Dmytro Gumenyuk

Challenges of Severe Accident Management at Ukrainian NPPs

Findings of the FCVS Review (1/2)

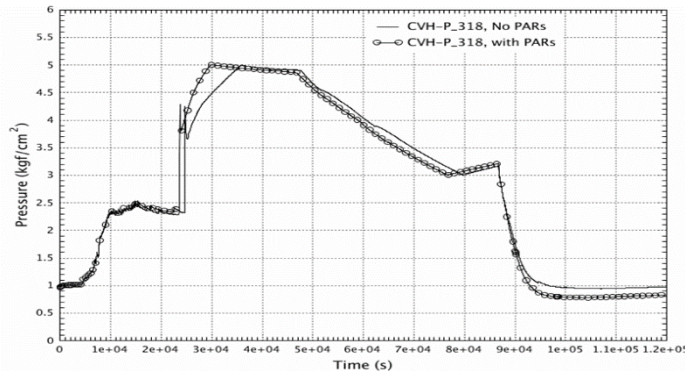
Comment

- Justification of setpoint of FCVS venting stop (3 kgf/cm²)
- FCVS justifications were performed without taking into account PARs
- MELCOR analysis of spray actuation and PARs accounting was conducted

Resolution

- PSAR should support the setpoints for the FCVS design
 - PSAR has accounted the updated justifications
- 
- Venting pipe diameter increased to 125 mm (previous 100 mm)
